TO:	CHAIR AND MEMBERS BUILT AND NATURAL ENVIRONMENT COMMITTEE
FROM:	DAVID AILLES MANAGING DIRECTOR OF DEVELOPMENT APPROVALS BUSINESS UNIT D.N. STANLAKE DIRECTOR OF DEVELOPMENT PLANNING
SUBJECT:	APPLICATION BY: 756949 ONTARIO LIMITED (AARTS/AAROC AGGREGATE LTD.) 1647 FANSHAWE PARK ROAD EAST MEETING ON NOVEMBER 14, 2011

Subject: 1647 Fanshawe Park Road East
Global Vision Investments Inc., 39T-10503
Potential Right-in-Right-Out Turn Lane
Technical Review

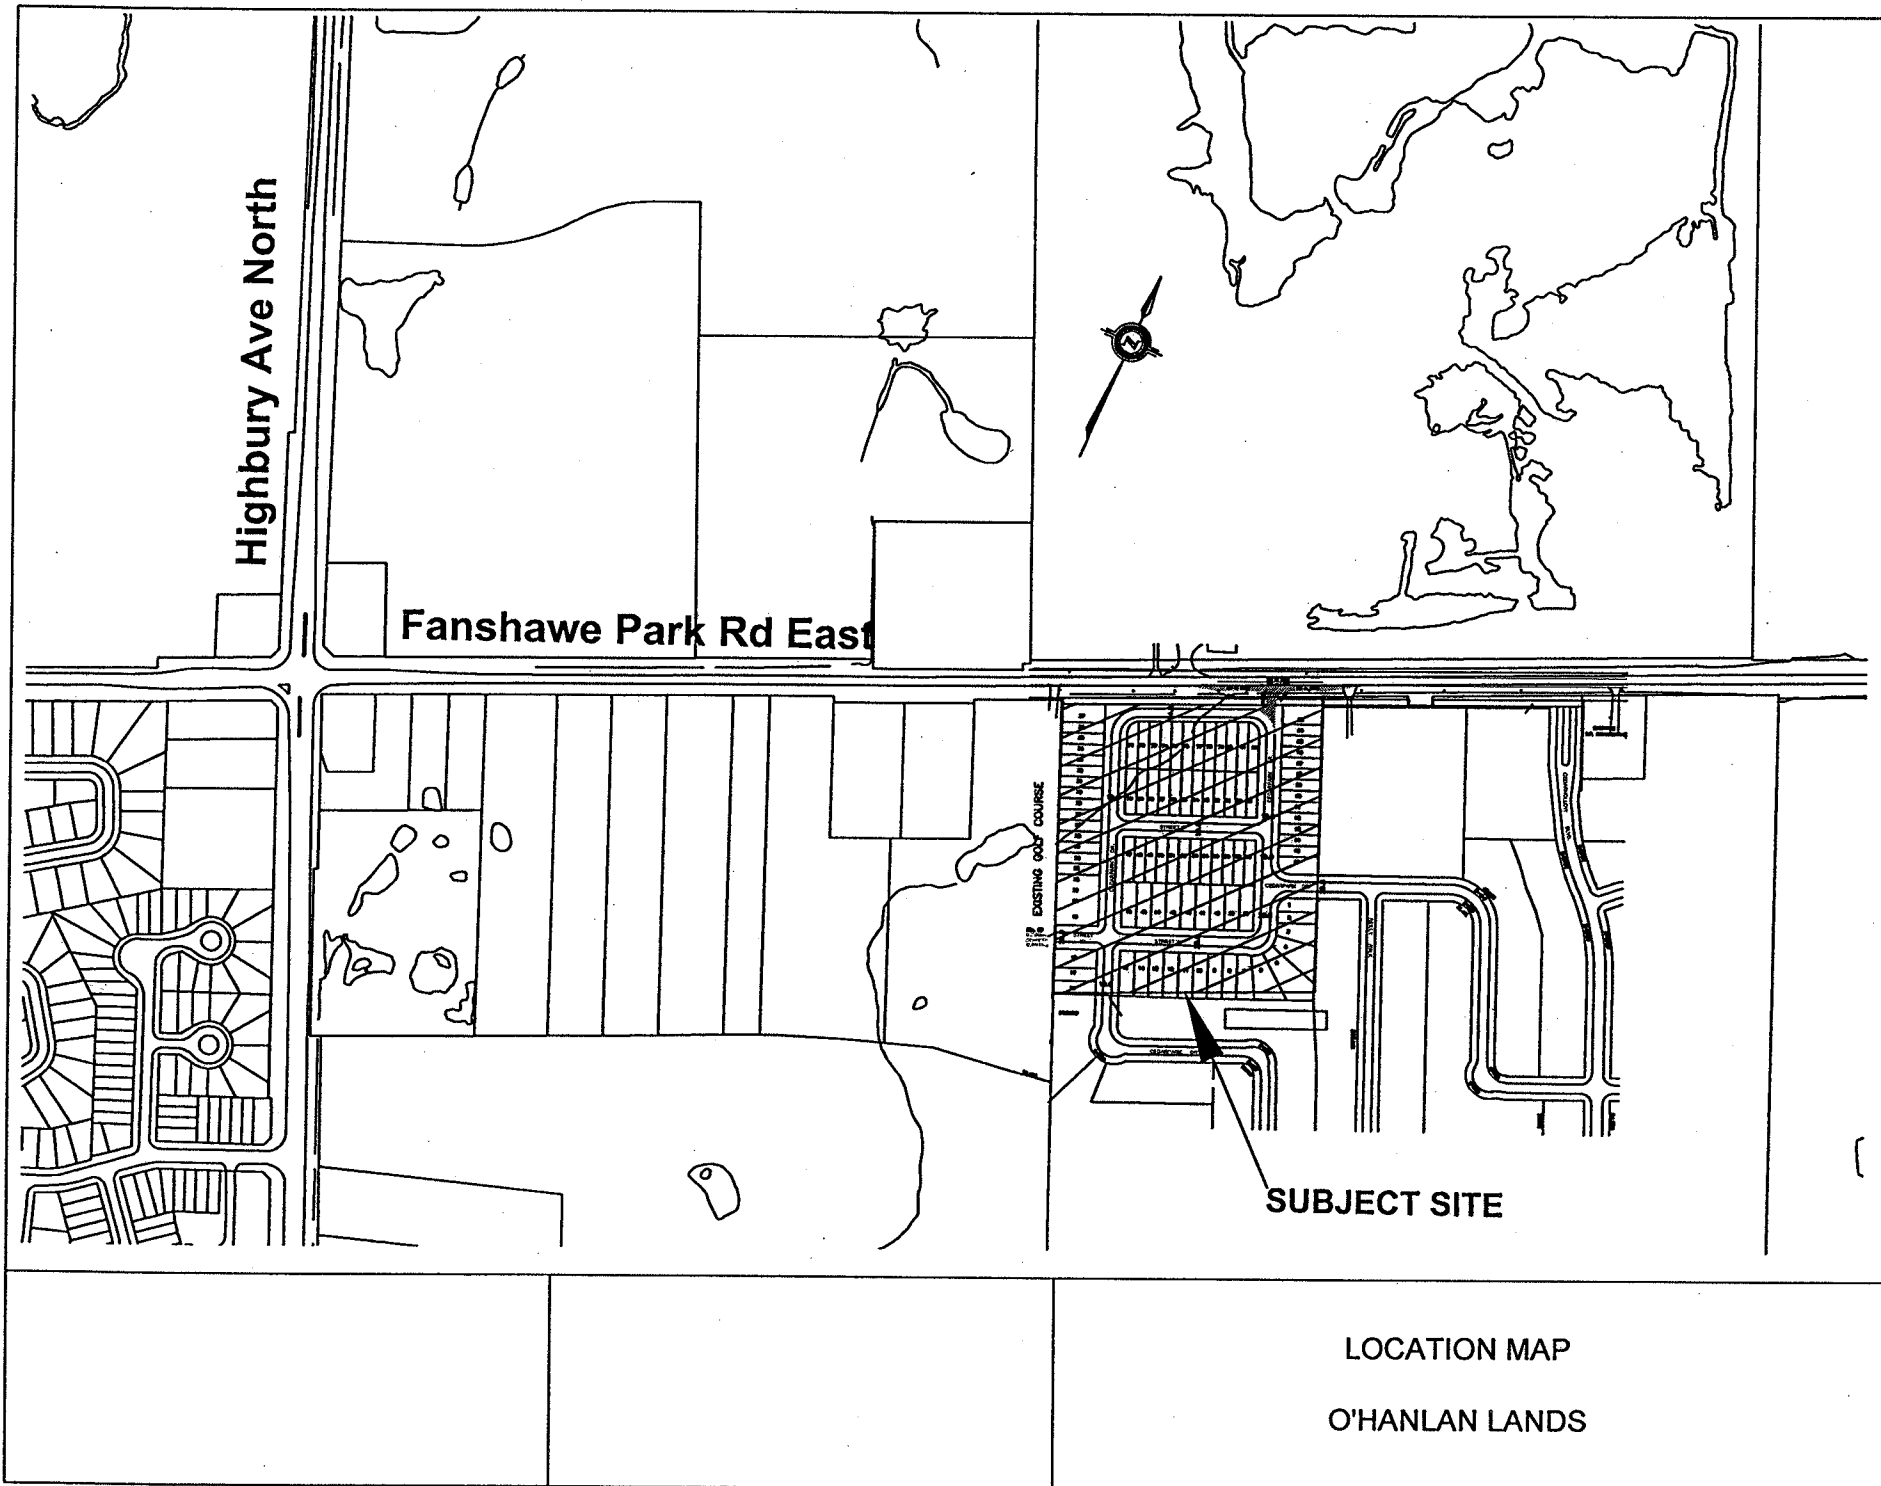
The applicant's consulting engineer has identified a right-in-right-out configuration on the easterly end of the window street to minimize traffic conflict. However, this configuration still results in a non-standard design that is further exasperated by the location of the window street adjacent to Fanshawe Park Road East. The proposed access cannot be built to standard, and therefore this non standard design will impact the local road system, and create additional traffic for internal streets that were not designed to handle additional traffic volumes.

Response: Typically, non-standard designs would not be acceptable in green-field locations, however, these non-standard designs may be acceptable if any safety concerns can be addressed and if utilities can still be located, to the satisfaction of the Utilities Coordinating Committee (UCC). The proposal has not been considered by the UCC. Further specific engineering evaluation will be required to be completed to determine if a safe access can be accommodated.

The other significant concern is the additional costs associated with this new road connection to Fanshawe Park Road East. City transportation staff has advised that they will only consider a centre barrier island to ensure right-in-right-out traffic and that other design measures (i.e. pork chop island) are not acceptable. As a consequence, this results in significant costs to widen the travelled portion of Fanshawe Park Road, in addition to slip off lanes and increased pavement depth within the subdivision to handle additional traffic. None of this was identified through the review of the subdivision application and it is the applicant's position that any additional costs should be the responsibility of the City.

Response: The City has the ability to require collector roads including intersections with arterial roads. This is a developer cost. The onus would be on the developer to fund the additional costs incurred.
